## **Sixteenth Amendment to the Regulating Plan (Approved May 24<sup>th</sup>, 2012)**

BlueStone Commons, LLC  
Village Center Development, LLC  
Woodland Commons, LLC

June 21, 2019

DRAWN BY: _____ DESIGNER: _____ CHECKED BY: _____ DESIGN TEAM		PHONE: 518.218.1000 418 W. SUPERIOR ST. 317.200 DULUTH, MN 55812	BLUESTONE DULUTH, MINNESOTA	OVERFLOW PARKING LOT GRADING PLAN	EXHIBIT A Page 1
		FILE NO. BLUST 120745	EXH. NO. 2

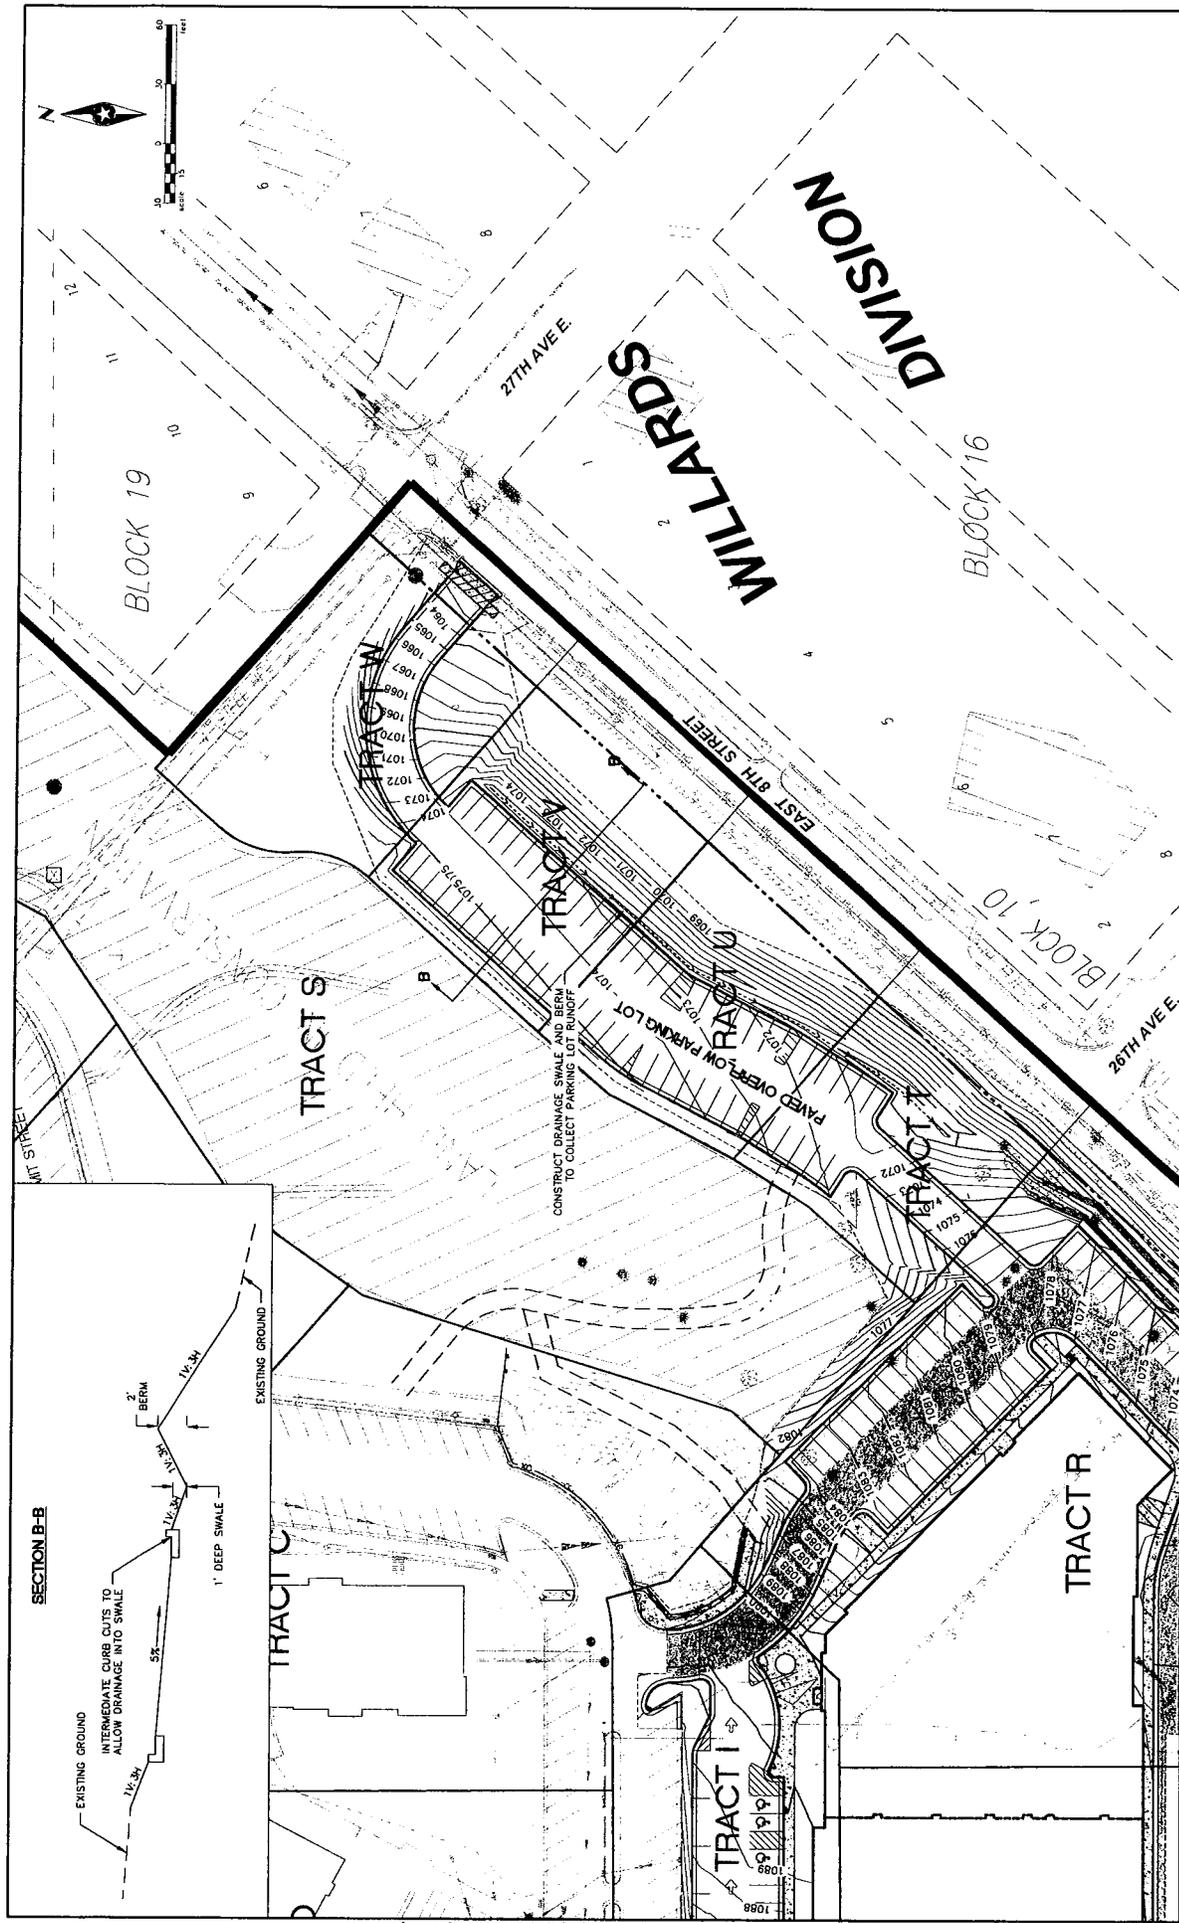
- a. For the purposes of Tract T, U, V, and W, the Unified Development Chapter 50-41, “Accessory use or structure” shall include the use of a parking lot (also known as a surface lot) as defined in the Unified Development Chapter 50-41 and required under the Unified Development Chapter 50-14.7(G)(9).
- b. The attached Exhibit A shall depict the Vue at BlueStone parking lot (surface lot) plan which is approved for construction.
- c. The Building Setback requirements for Tract T, U, V, and W, shall be amended and restated as follows:
